Remarks:
 frequency potmeter connections pin2 and pin3
 C9-C10, 10nF
 C18-C19, 100nF
 C32-C33, 220nF
 C38-C39, 470nF (50Hz-350Hz)

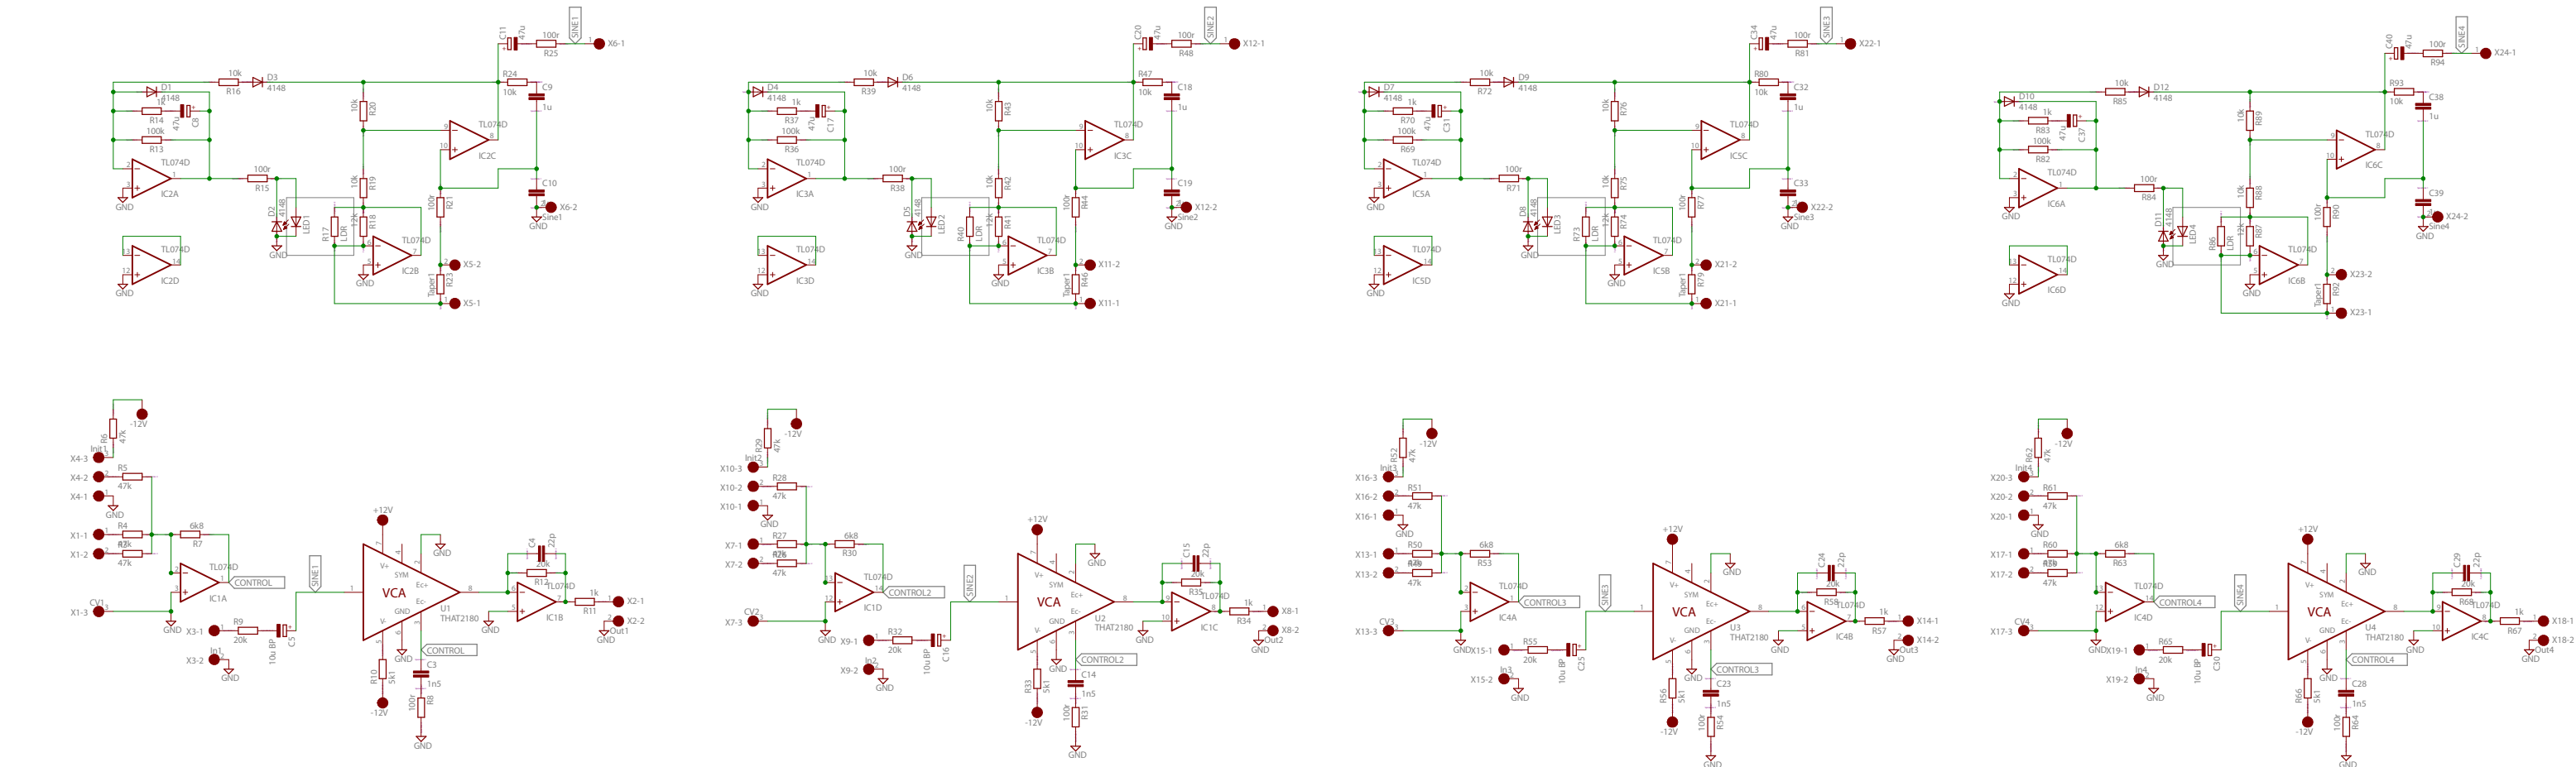
Increase R across LDR if no oscillations (R17 et al.)

Change R15, R38... to 220r or 390r (first is max output current opamp, still out of spec max current for vactrol, 390r keeps current for vactrol (25mA) within spec.
